CITY OF ALBUQUERQUE

October 13, 2023

Re: SureStay Hotel Conversion
10330 Hotel Ave. NE
Traffic Circulation Layout
Architect's Stamp 09-29-23 (K21-D016F)

A1 SITE PLAN
1" = 20'-0"

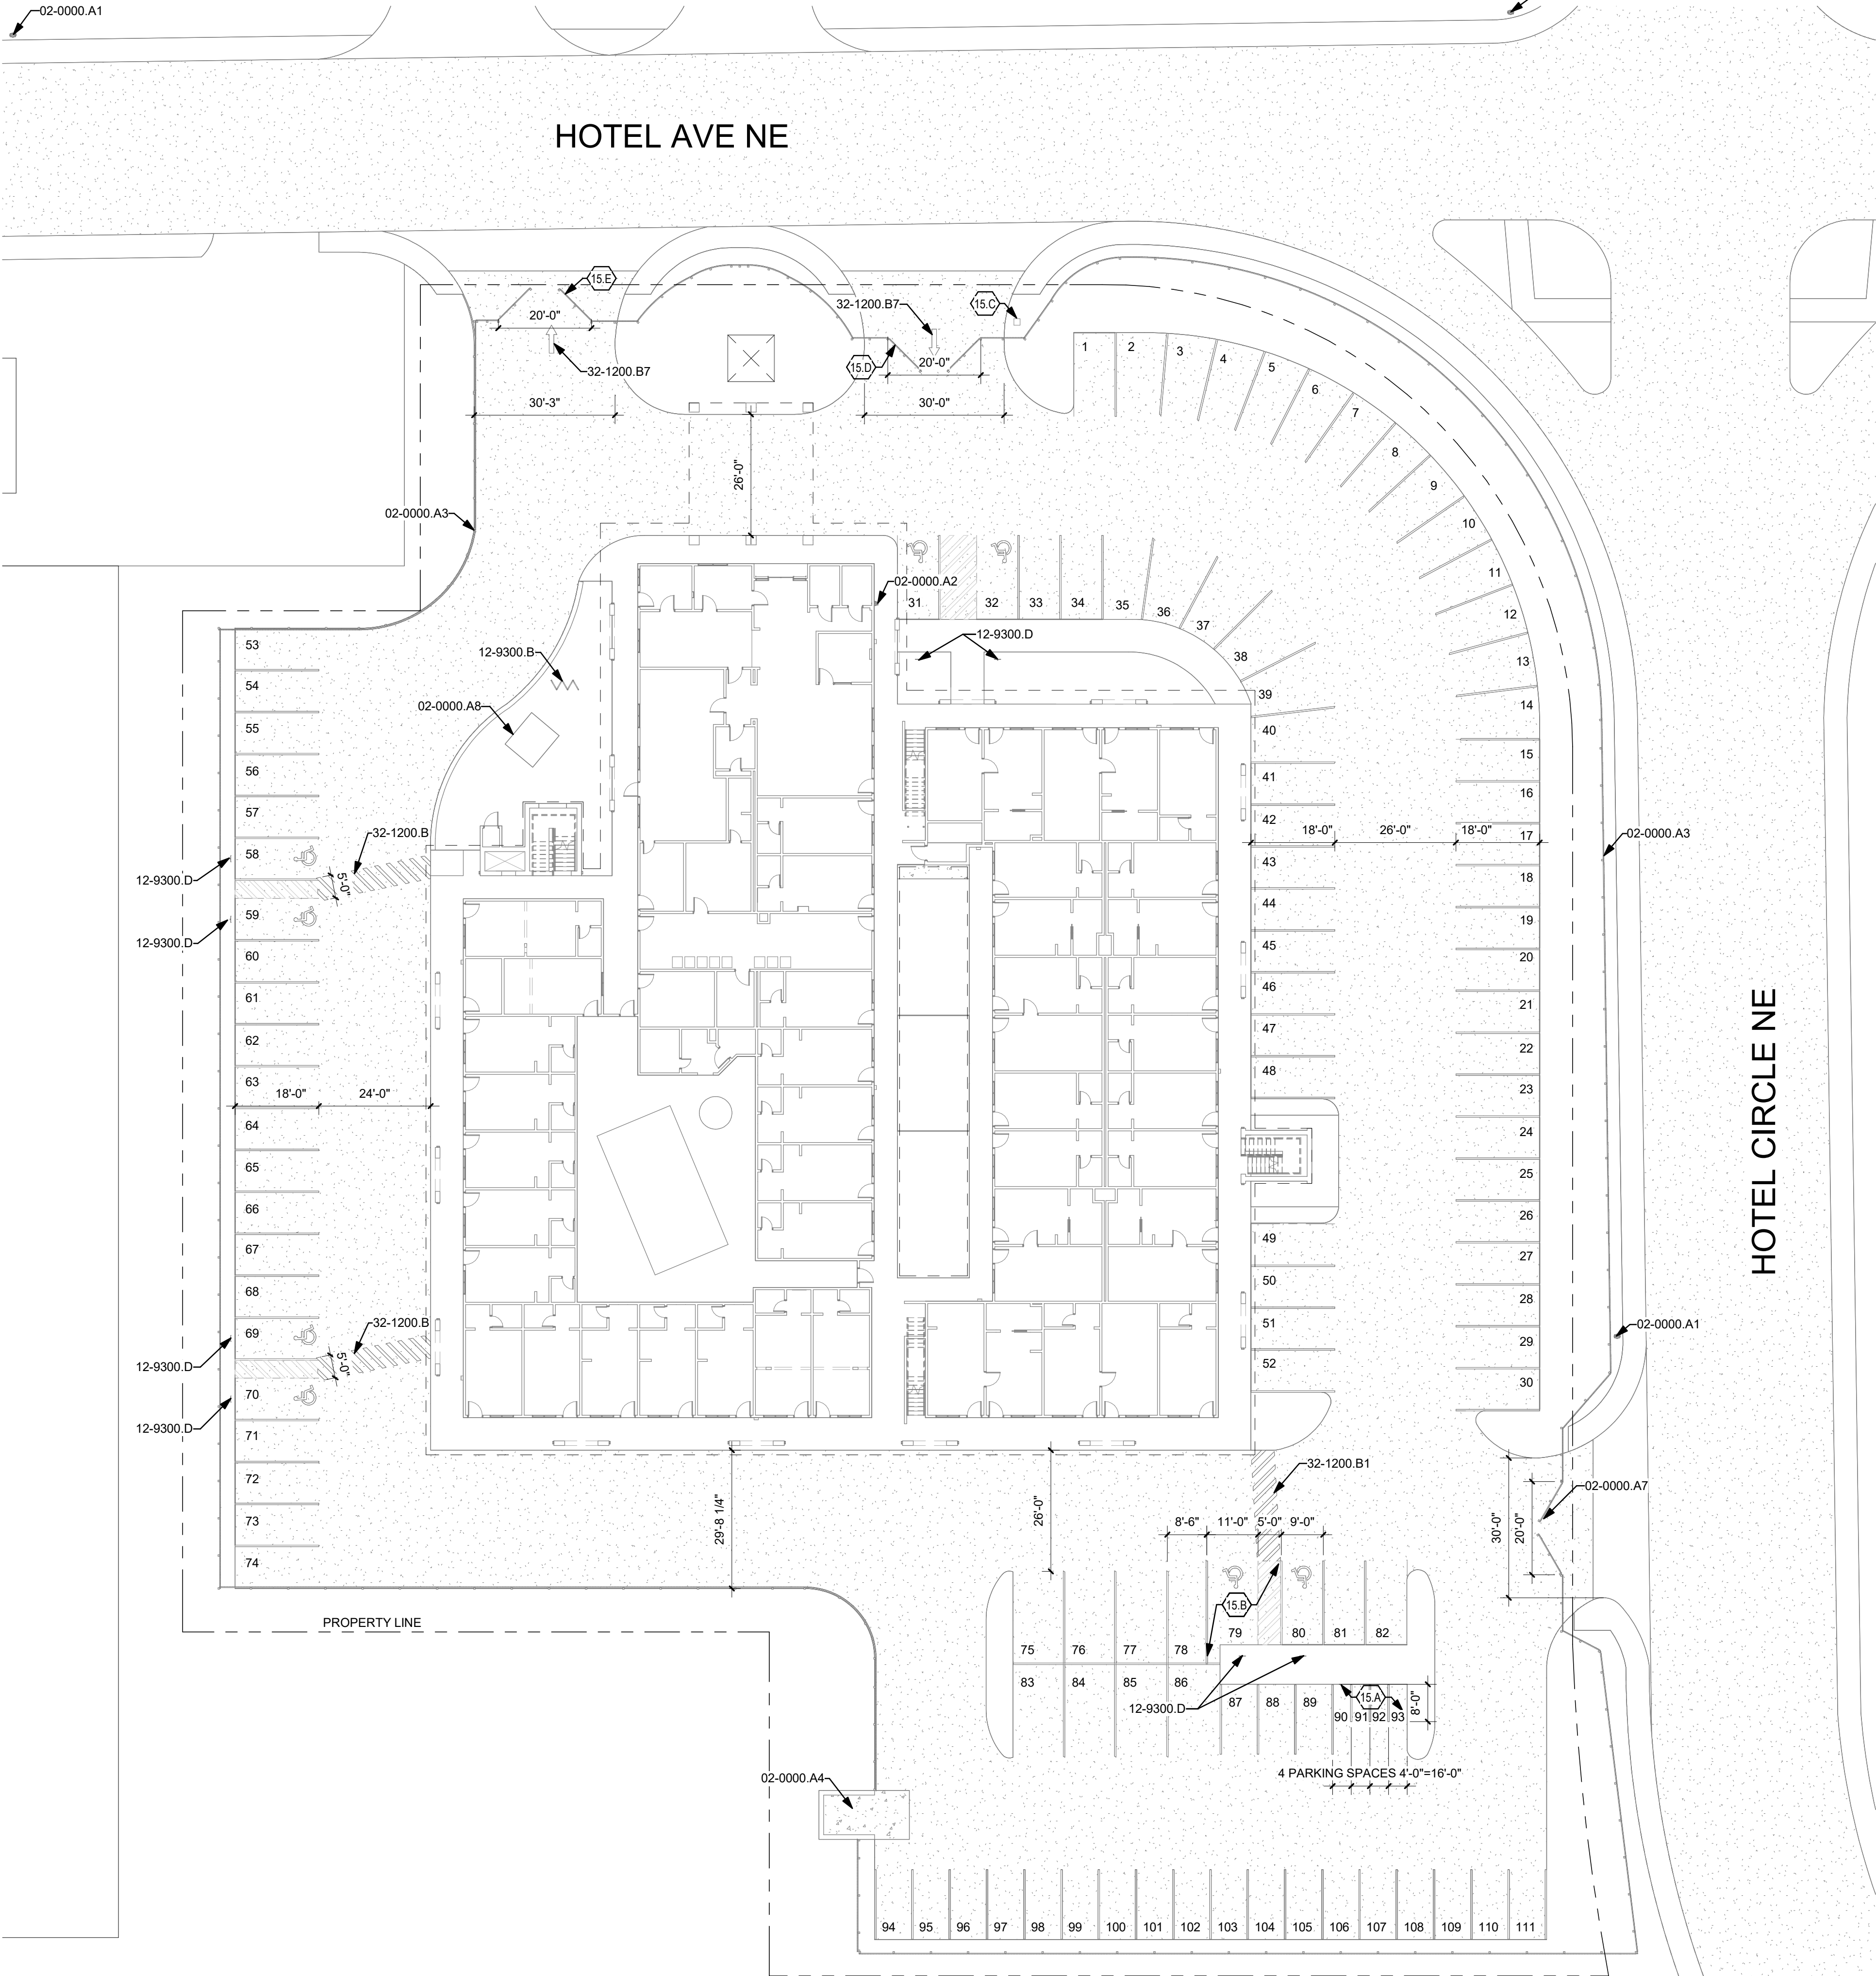
1. Please show a vicinity map showing the location of the development in relation to streets and well-known landmarks.
2. List the number of Bicycle parking spaces required by the IDO.

3. Keynote 02-0000A3: It appears the existing fence located within the public right of way. Any private structures that are located within public right-of-way such as fences and walls shall either be removed or else a revocable permit with the City is required in which an annual fee is paid per year, based on square footage of the encroachment.

4. Site Accesses:
 - All site accesses curb ramps must be updated to current standards and have truncated domes installed.
 - Please show on the site plan the necessary turnarounds in front of the gates. Because if a vehicle pulls up to the gate and is unable to enter, there should be sufficient space needs for the vehicle to turn around without backing into the roadway.

- All one-way drives shall have "One Way" and "Do Not Enter" signage and pavement markings. Please show detail and location of posted signs and striping.

5. Please list the width and length for all existing and proposed parking spaces. Some dimensions are not shown.
6. The ADA accessible spaces must include an access aisle. Van accessible aisles should be 8ft wide; all others should be 5ft wide.

7. The ADA accessible parking sign must have the required language per 66-7-352.4C NMSA 1978 **"Violators Are Subject to a Fine and/or Towing."** Please call out detail and location of signs.

8. The ADA access aisles shall have the words **"NO PARKING"** in capital letters, each of which shall be at least one foot high and at least two inches wide, placed at the rear of the parking space so as to be close to where an adjacent vehicle's rear tire would be placed. (66-1-4.1. B NMSA 1978)
9. ADA curb ramp at the corner of Hotel Ave. and Hotel Circle must be updated to current standards and have truncated domes installed.
10. Please show on the site plan these drive aisles width.

11. Motorcycle parking spaces shall be designated by its own conspicuously posted upright sign, either free-standing or wall mounted per the zoning code.

12. The pavement marking "MC" should be shown in the opposite direction for motorcycles entering the parking space.
13. All bicycle racks shall be designed according to the following guidelines:

17. Per the IDO, a 6 ft. wide ADA accessible pedestrian pathway is required from the public sidewalk to the building entrances. Please clearly show this pathway and provide details.

18. Per DPM, a 6 ft. wide ADA accessible pedestrian pathway is required from the ADA parking stall access aisles to the building entrances. Please clearly show this pathway and provide details.

19. Please clarify the ADA pathways by clearly labeling flush surface or ramps and show the doorways on the site plan. Please ensure that all interior ADA curb ramps are updated to current standards.

20. Show the clear sight triangle and add the following note to the plan: "Landscaping and signage will not interfere with clear sight requirements. Therefore, signs, walls, trees, and shrubbery between 3 and 8 feet tall (as measured from the gutter pan) will not be acceptable in the clear sight triangle.

21. Please specify the City Standard Drawing Number when applicable.
22. Add a note stating "All broken or cracked sidewalk must be replaced with sidewalk and curb & gutter." A build note must be provided referring to the appropriate City Standard drawing.
